Cushion Rail Information Panther Update

The Valley Panther tables introduce our new 5-bolt Rail System (patent pending)

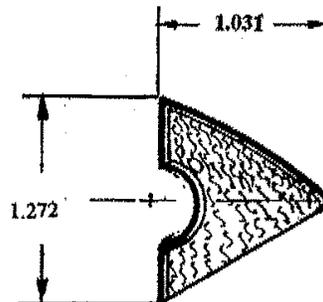
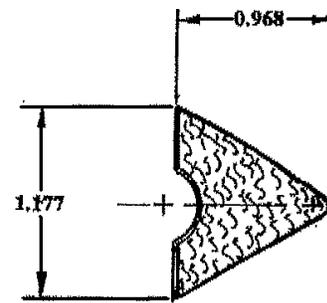
Valley-Dynamo has used three different profiles of cushion rail rubber: U-23, K-55 and the current spec – K-66. When changing your rail sets it is critical that the profile is consistent. Valley switched from U-23 to K-55 in 1989 and from K-55 to K-66 in 1999. Dynamo switched between K-55 and K-66 several times, based on player and Operator preference.

U-23—prior to 1989

K-55—1989-1999

K-66—current use

Our Dual Density K-66 rubber is optimized for shot accuracy, but may not play as fast as other rubber profiles. Based primarily on feedback received from Tournament play, this is our rubber of choice for new production tables and replacement cushion rails.

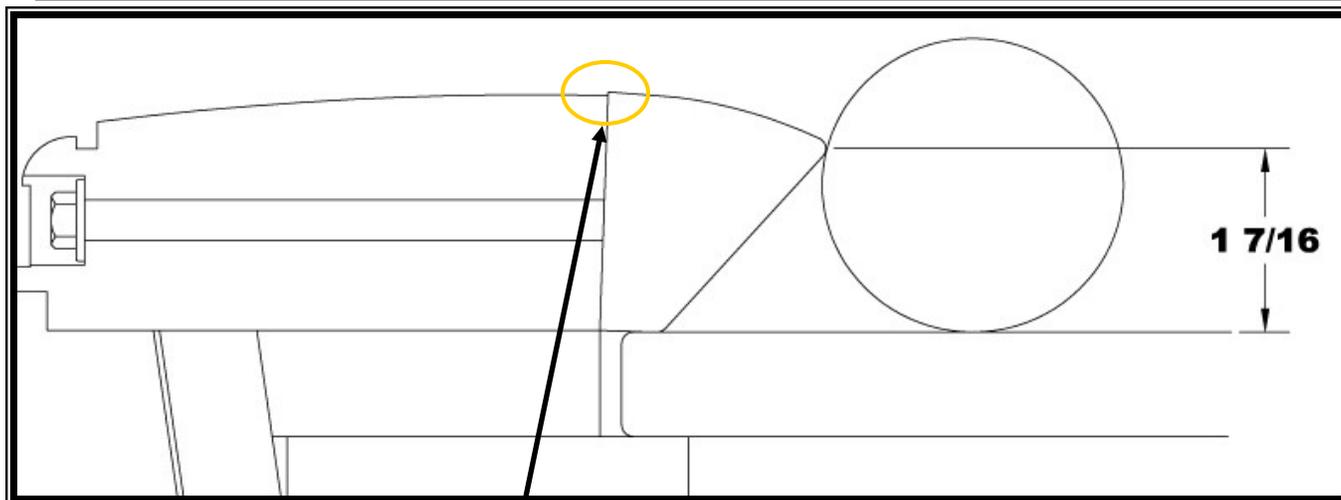
What's different?

Two additional rail-bolt attachment points added
Now using Threaded Inserts instead of T-nuts
Small dead spots in rubber now eliminated

Will the new rails fit my existing table? YES. We kept the center and outermost bolt locations unchanged. If your table uses three bolt rails, the five bolt rails should fit just fine. For tables built prior to 1998, the same rules apply for using newer rails on older tables. The table modification procedure—outlined in our Pool School—is unchanged. Likewise, for old tables where the rails attach with wood screws, these rails will also not work.

Can I modify my table so the Cushion Rails attach with five bolts? Specialized CNC equipment ensures the bolt holes are correctly located on new tables. While modifying an older table is possible, it is not recommended.

What are the advantages to the new system? First, going to a five-bolt system on the new Valley Panther and Panther ZD-X tables allows for more secure attachment without risking overtightening the bolts. Now if one rail bolt backs out, comes loose, breaks, FOUR Bolts shoulder the rest of the load instead of two, and the load is evenly distributed. Second, the Threaded Inserts can be more easily replaced in the field and are less likely to strip. Third, the threaded inserts allowed us to eliminate the gaps shown in the photo at left. The small dead spots these gaps allowed are now gone, and the cushion rail rubber can do its job more effectively.
